**VICTORIA PARADE PEDESTRIANISED ZONE – Member Highway Fund Scheme
RESULTS OF CONSULTATION**

Summary: **The report summarises the results of the public consultation for a new pedestrian zone and associated footway widening with block paving in Victoria Parade, Broadstairs.**

VICTORIA PARADE, BROADSTAIRS PEDESTRIANISED ZONE – Member Highway Fund Scheme

13-MHF-TH-26/1201

Annex 1 – Scheme Proposal / Plan

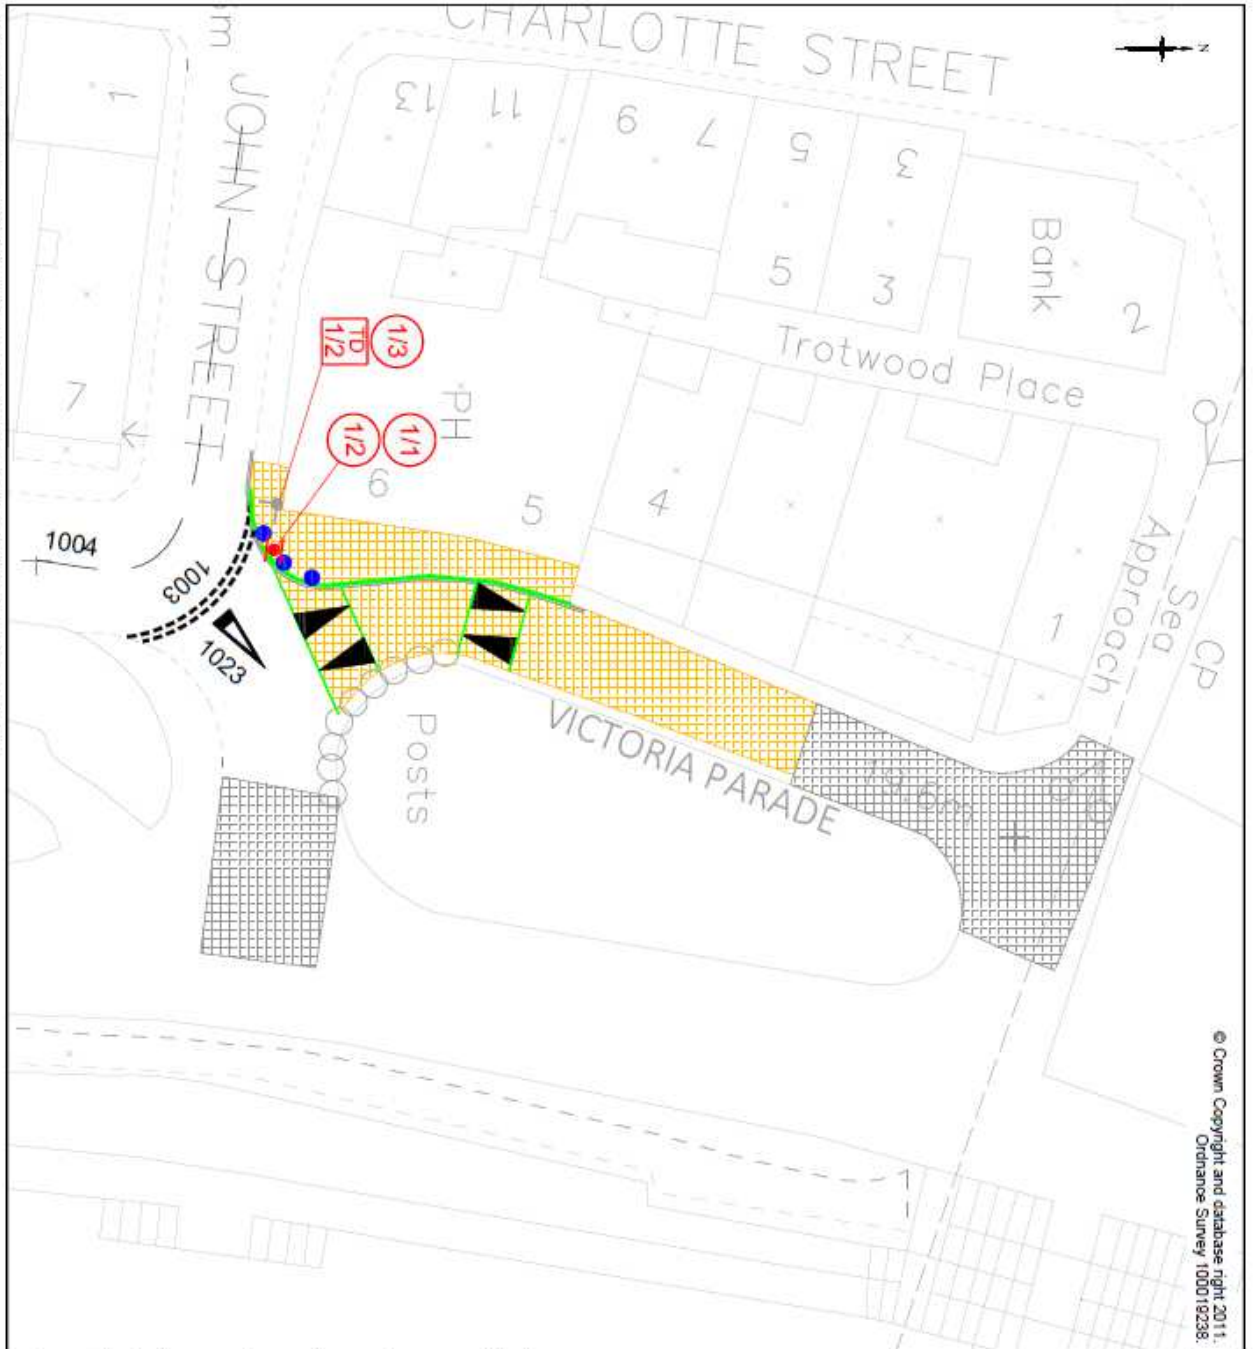
Item	Comment received	KCC response
1.	The installation of a pedestrianized zone will impede access for deliveries in Victoria Parade.	The prohibition of motor vehicles will be restricted to the hours of 10am and 4pm, and will remain open for access. No signage, tables or chairs can be placed in the vehicular carriageway without ensuring access is maintained at all times and the appropriate licence agreement in place.

2.	The proposed scheme will greatly enhance the area and continue the improvements previously made outside the Dickens Museum which appeared somewhat unfinished.	The scheme will ensure that the block paving extends for the whole length of the Victoria Parade cul-de-sac, tying in with the paving already present at the turning point.

3.	There is no justification for the high cost associated with block paving when the existing road surface is in very good condition. Furthermore the proposals specify a different colour paving to that which is already present elsewhere in the road.	Comment noted. We will amend the proposals to include block paving to match that already existing on site.

4.	There is already a pedestrianized area nearby i.e. the promenade. Victoria Parade receives very little use by pedestrians except when coming to visit the Dickens Museum.	The scheme aims to make Victoria Parade more user friendly for pedestrians by reducing vehicle movements in the road and improving the amenity of the area.

7.	I am disabled and regularly park in Victoria Parade on the double yellow lines and display my blue badge. If this proposal goes ahead I will no longer be able to park in the cul-de-sac.	Comment noted. As detailed earlier in this report, the scheme does not remove any on street parking provision, but would stop blue badge holders from parking in the pedestrianized area.

8.	I regularly walk in this area with my family, and find it very dangerous when delivery vehicles turn in the restricted space especially during the day when the road can get quite busy. I think that the prohibition should be extended until 7pm.	Comment noted. The scheme does aim to reduce the amount of vehicles using the cul-de-sac during the busiest periods of the day. However, we do need to make provision for deliveries to the local businesses so would not recommend extending the prohibition.

9.	The ongoing maintenance costs of the block paving are expensive, and the site will end up looking a mess with black top patching.	As this is a cul-de-sac the road surface is less trafficked and thus requiring less future maintenance. All utilities companies should return the road surface to its previous state before leaving site.
